FINAL PLAT
HENTZEN ADDITION
 TO SEDGWICK COUNTY, KANSAS

RE: SUB 2002-89 -- One-Step Final Plat of Hentzen Addition

STAFF REPORT
(ONE-STEP FINAL PLAT APPROVED 9/5/02)

CASE NUMBER: SUB 2002-89 – HENTZEN ADDITION

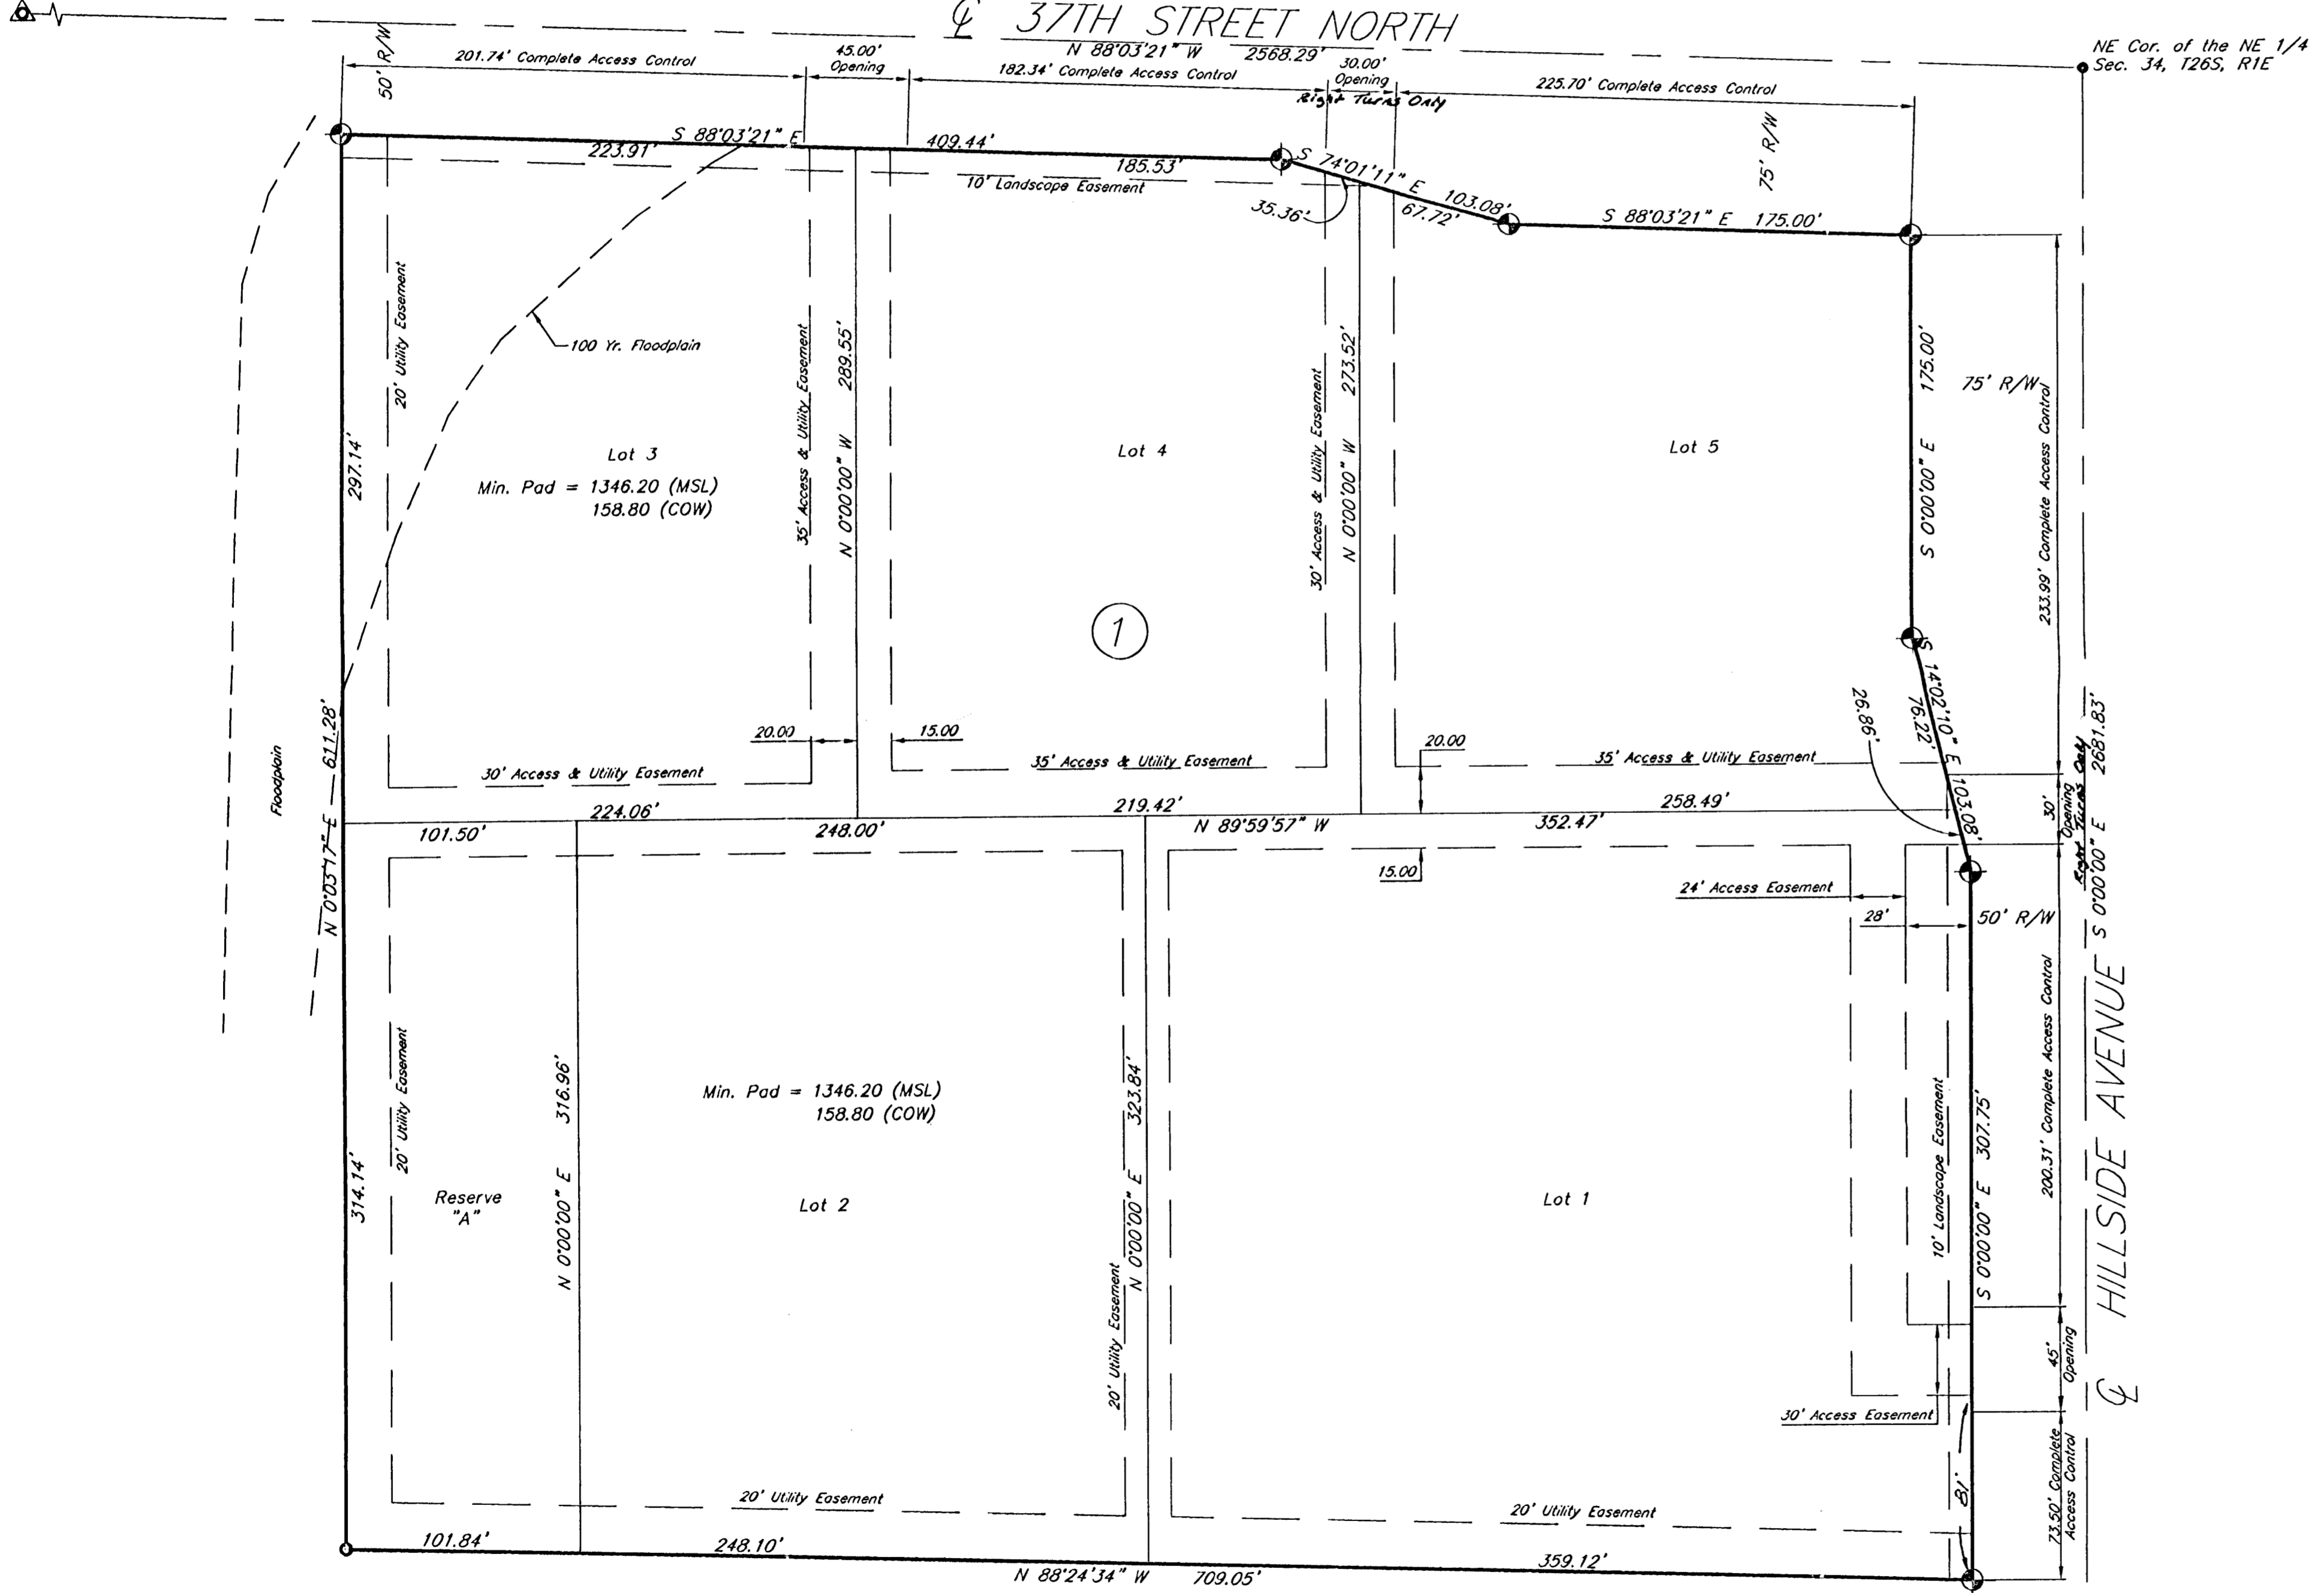
- D. The plattor's text shall include the standard floodway language.
- E. The plat proposes two access openings along both arterials. The openings along 37th St. North are approved. In accordance with the Access Management Policy, the openings along 37th St. North and Hillside closest to the intersection need to be rights-in/out and denoted on the face of the plat. A guarantee is required for construction of a channelized rights-in/out opening. The opening along Hillside located along the south line of the plat is approved as a joint opening with the property to the south, contingent upon closure of the existing opening for the property to the south. In the event, the existing opening for the property to the south is not closed, then this opening should be relocated to be in alignment with the northernmost opening for the property across Hillside. Distances should be shown for all segments of access control. The final plat shall reference the dedication of access controls in the plattor's text.

- I. **Traffic Engineering** has requested additional right-of-way along both arterials. The Access Management Policy requires a 60-ft half-street right-of-way width along urban arterials. The Policy also requires an additional 25-ft x 25-ft corner clip at the intersection. **The Subdivision Committee approved a 50-ft half-street right-of-way.**

- M. On the final plat tracing, the MAPC signature block needs to reference "Michael E. Lindebak, Secretary".
- N. On the final plat, the MAPC signature block needs to reference "J.D. Michaelis, Chair".

- O. A signature line needs to be added for the owners.
- P. The Applicant is reminded that a platting binder is required with the final plat. Approval of this plat will be subject to submittal of this binder and any relevant conditions found by such a review.

- Q. The plattor's text shall include language that a drainage plan has been developed for the plat and that all drainage easements, rights-of-way, or reserves shall remain at established grades or as modified with the approval of the applicable City or County Engineer, and unobstructed to allow for the conveyance of stormwater.
